**SUSQUEHANNA STEAM ELECTRIC STATION  
PROPOSED AMENDMENT NO. 281 TO LICENSE NPF-14  
AND PROPOSED AMENDMENT NO. 251 TO LICENSE NPF-22:  
“APPLICATION FOR LICENSE AMENDMENT AND  
RELATED TECHNICAL SPECIFICATION CHANGES  
TO IMPLEMENT FULL-SCOPE ALTERNATIVE SOURCE  
TERM IN ACCORDANCE WITH 10 CFR 50.67 – FOLLOWUP  
TO REQUEST FOR ADDITIONAL INFORMATION (RAI)” Docket Nos. 50-387  
PLA-6119 and 50-388**

Attachment – Markup of Drawing E105023 Sht.1

**Markup of Drawing E105023 Sheet 1**

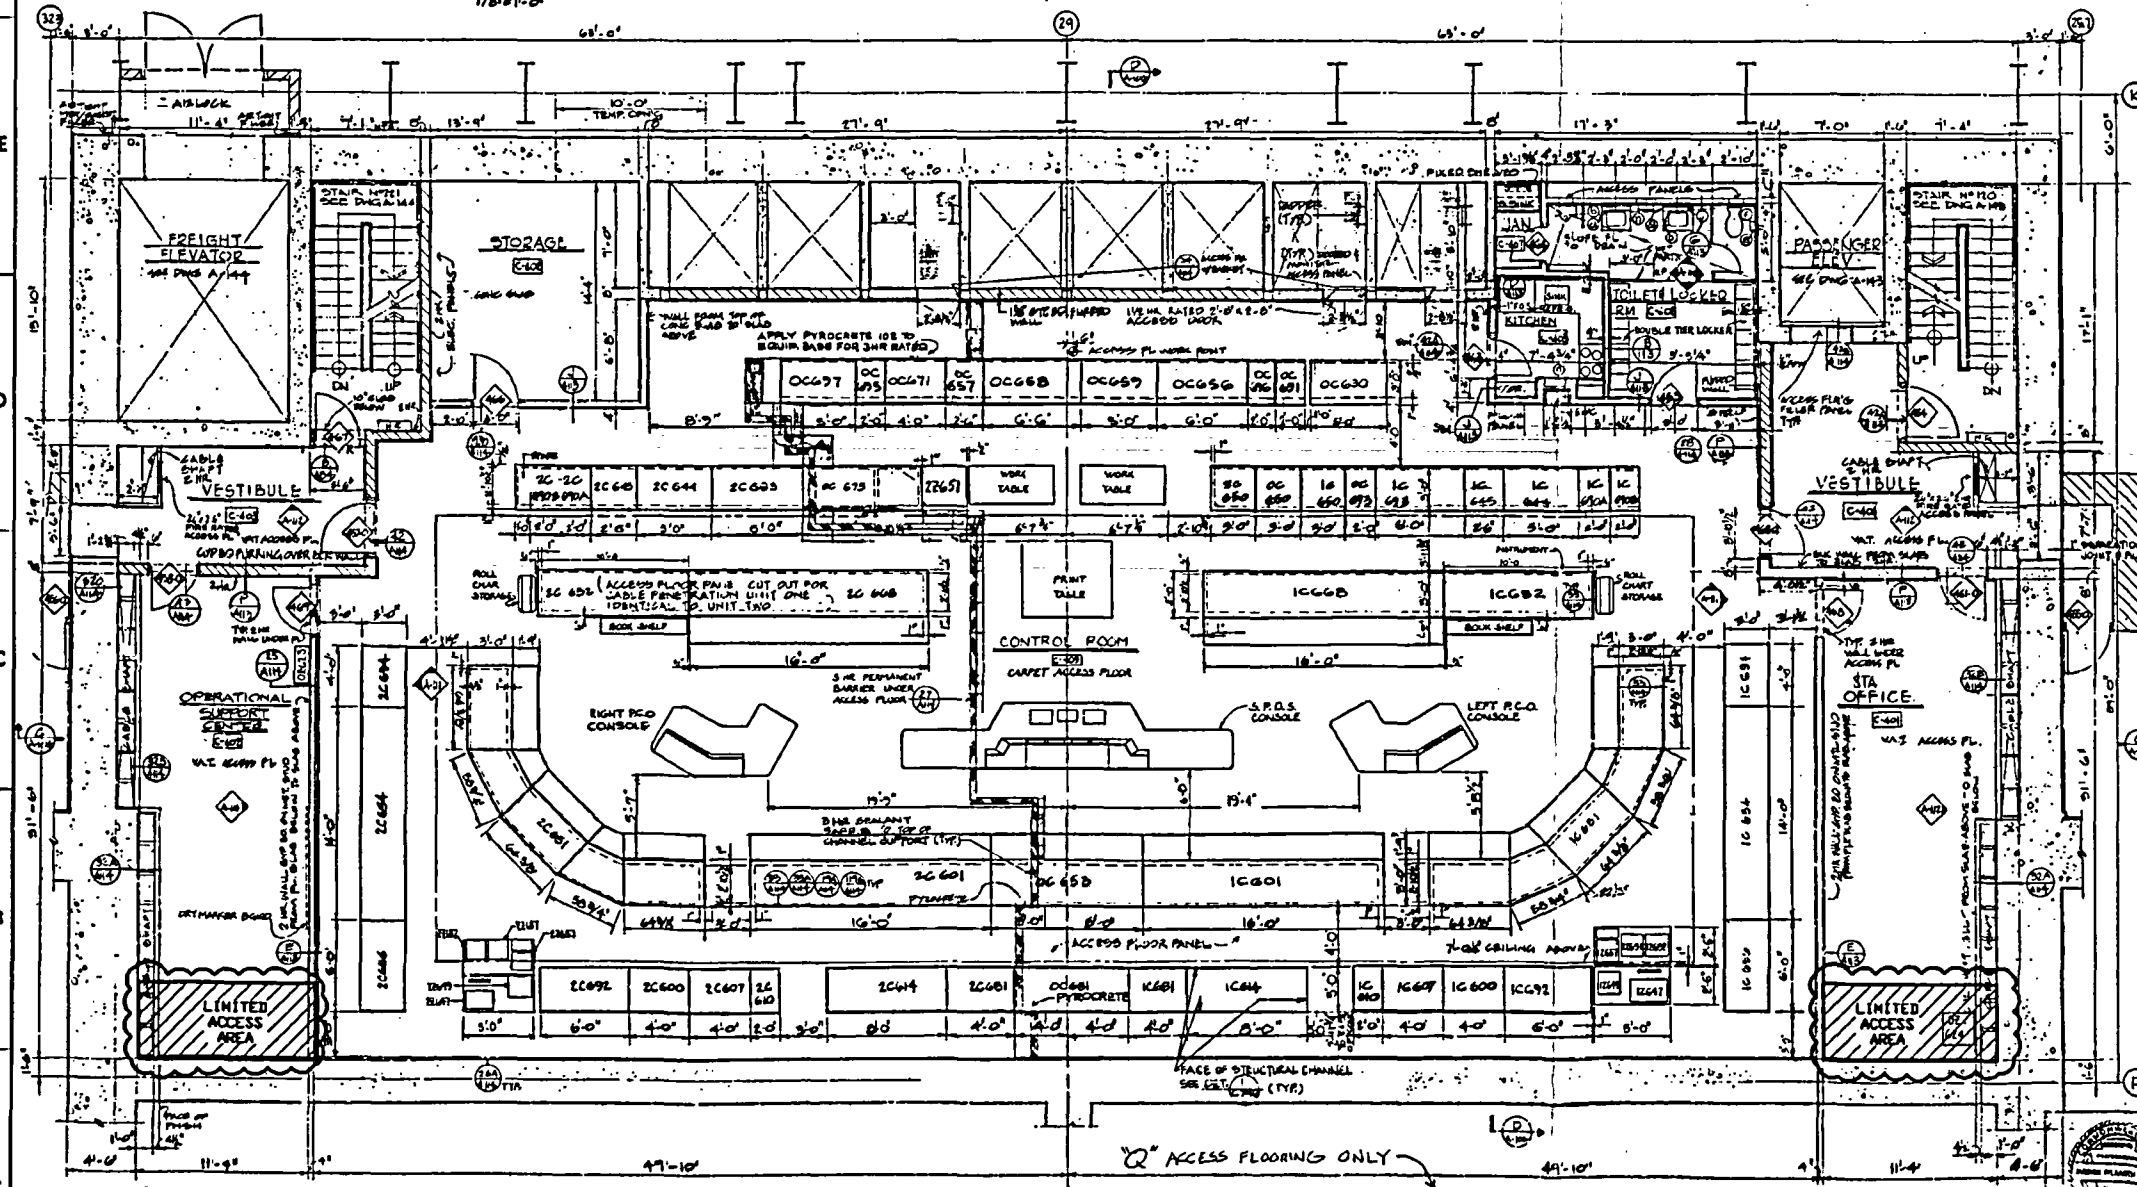
The purpose of this letter is to transmit the attached figure, inadvertently omitted from Reference 1, which provided PPL’s response to the NRC RAI Question #7. This marked up floor plan drawing shows the two office spaces on elevation 729’ that are adjacent to the main control room and two areas on elevation 741’ that are adjacent to the Technical Support Center (TSC), identified as an area of concern in the RAI.
